SERVICE BULLETIN # 1993 - 127

APPLICABILITY: Riblet chairlifts furnished 1984 thru 1987 using tension-drive terminal with #5599 strut. (see attached sketch "A")

SUBJECT: Inspection and replacement of #5599 strut

TITLE SKETCH "B"

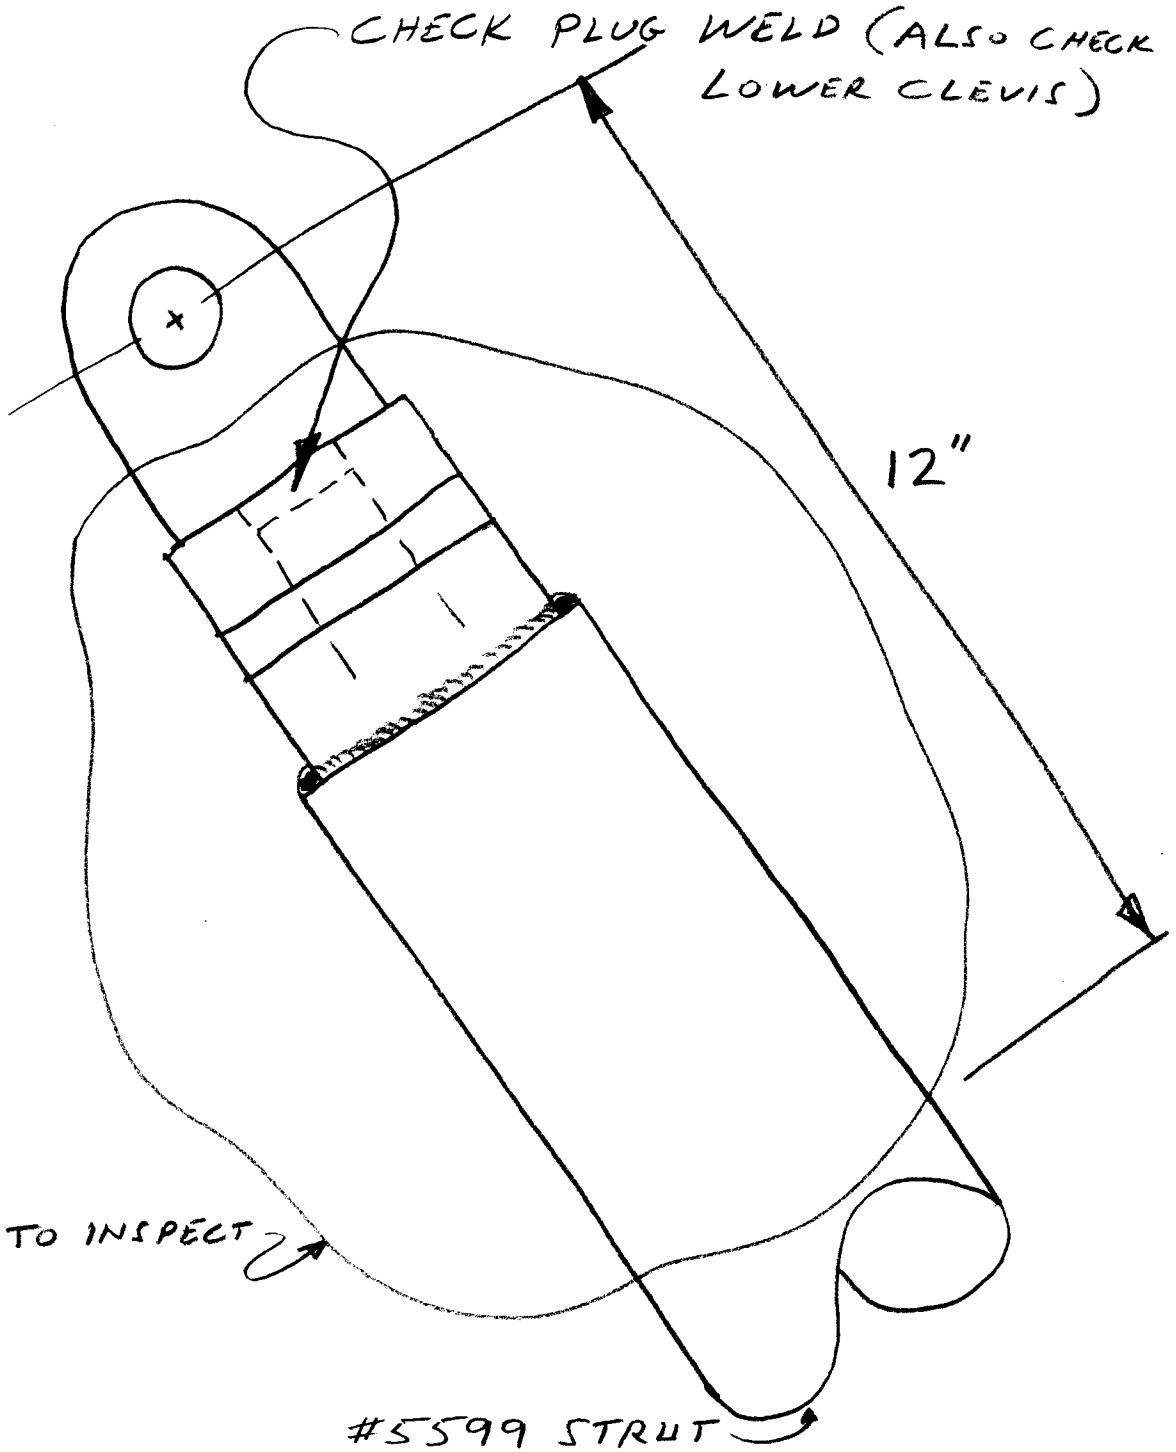
Immediately (that means right now) conduct a visual inspection of the area circled on attached sketch "B". Use a magnifying glass and good lighting conditions, remove paint if necessary, and pay special attention to the plug weld in the center of the clevis. If any cracks are found, do not operate the lift. Contact Riblet Tramway Company for help. Repeat this inspection at two week intervals for the remainder of this ski season.

AREA TO INSPECT

SKETCH "A"

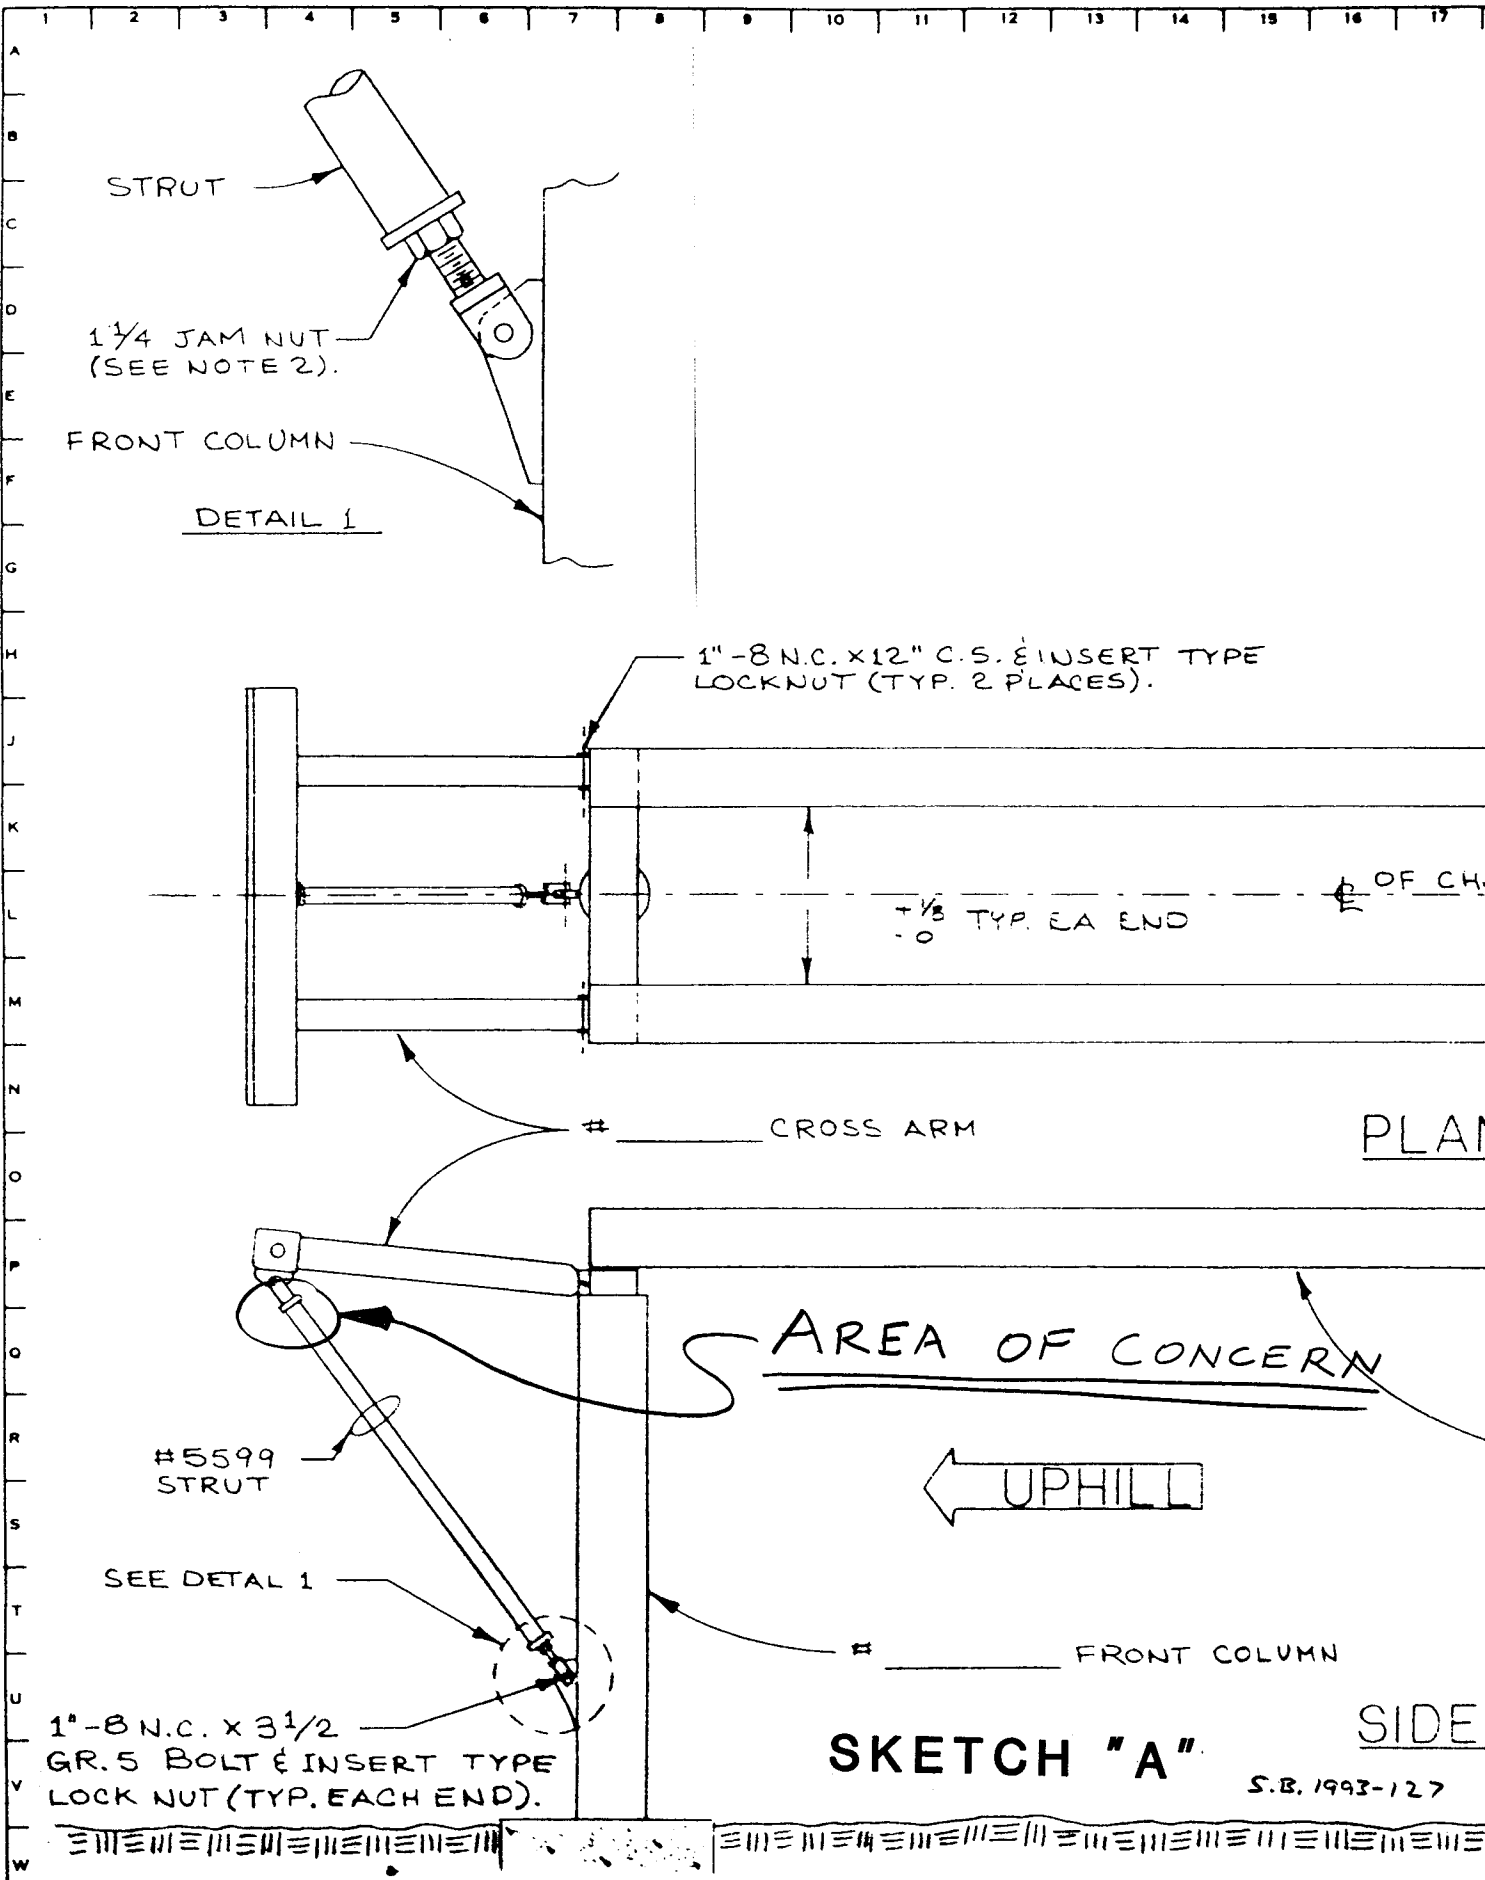
We have determined that the cause of this failure was lateral rocking of the machinery cross arm, which imposed a bending moment at the upper end of the strut. In order to prevent any future failure of the subject strut, the following three-part program is mandatory:

Check the 1" bolt through the upper end of the strut. It should not be tight. If necessary, back the self-locking nut off a turn so that lateral rocking of the cross arm will not impose bending moment of the strut. We want some "slop" here.

AREA OF CONCERN

At the end of the 1992-1993 ski season, the Riblet Tramway Company will ship to you, a modification kit to replace the single strut with the later "V" strut arrangement as used on more recent Riblet lifts. This "V" strut eliminates the rocking motion of the cross arm. We will furnish these parts at cost, and installation is relatively simple.
